# UNITED STATES PATENT AND TRADEMARK OFFICE

APPLICATION NO.	FILING DATE	FIRST NAMED INVENTOR	ATTORNEY DOCKET NO.	CONFIRMATION NO.
10/088,086	03/21/2002	Shouichi Fuji	221109US2PCT	7109
22850	7590	10/20/2004	EXAMINER	
OBLON, SPIVAK, MCCLELLAND, MAIER & NEUSTADT, P.C. 1940 DUKE STREET ALEXANDRIA, VA 22314			THAI, LUAN C	
			ART UNIT	PAPER NUMBER
			2829

**Office Action Summary**

### DETAILED ACTION

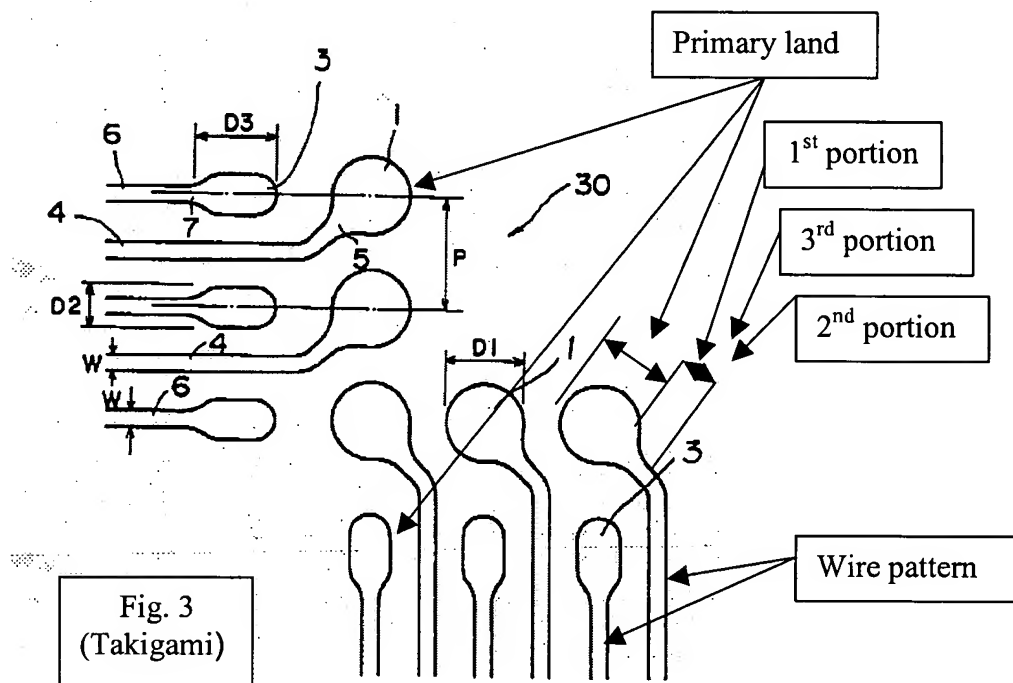
Takigami while related to a similar grid array electronic component design teaches (see specifically figures 3 and 8 attached) the land-wire structures formed on the printed circuit board (see figure 3) for electrically connecting to a semiconductor chip (see figure 8), the land-wire structures comprising: a primary lands (1/3) and an auxiliary lands (5/7) connecting to wires (4/6) where a predetermined tensile stress is configured to be applied between the lands and the wires. Takigami further discloses the primary lands (1/3) comprising a tear drop shape, and the auxiliary lands (5/7) comprising a first portion

Takigami while related to a similar grid array electronic component design teaches (see specifically figures 3 and 8 attached) the board land structure formed on the printed circuit board (see figure 3) for electrically connecting to a semiconductor chip (see figure 8), the board land comprising: a primary portion (1/3) having a circular shape and an auxiliary portion (5/7) having an about triangular shape or a tear drop shape electrically connected to wires (4/6). Takigami further discloses the auxiliary portion (5/7) comprising a first portion electrically connected to the primary portion (1/3) and a

Regarding claims 3-4, the primary land (18), which is electrically connected to the first land (14) at the corner of the semiconductor chip (12), as shown in Sherman's figures 1 and 3, is assumed to be modified to have a structure of the auxiliary land (5) electrically connected to primary land (1), as shown in Takigami's figure 3, as described

Regarding claim 5, the Examiner assumes that the structure of (primary land)-(auxiliary land)-(wiring pattern) in the proposed component of Sherman and Takigami comprises the auxiliary land (5) electrically connected to primary land (1) and the wire (4) as shown in Takigami's figure 3, and the primary land (18) configured to be disposed so as to extend in a direction in which a warpage of the board (20) is generated as shown in Sherman's figures 1-3; thus, the auxiliary land, in the proposed structure of Sherman and Takigami, is also assumed to be configured to be disposed so as to extend in a direction in which a warpage of the board is generated.

Takigami disclose the auxiliary portion (5/7) has a tear drop shape (see Takigami's figure 3). Although the proposed structure of Sherman and Takigami does not teach the exact shape of the auxiliary portion as that claimed by Applicant, the shape differences are considered obvious design choices and are not patentable unless unobvious or unexpected results are obtained from these changes. Additionally, the Applicant has presented no discussion in the specification which convinces the Examiner that the particular shape of *the auxiliary portion* is anything more than one of numerous shapes a person of ordinary skill in the art would find obvious for the purpose of smoothly connecting between the primary portion and the wire. *In re Dailey*, 149 USPQ 47 (CCPA 1976). It appears that these changes produce no functional differences and therefore would have been obvious.
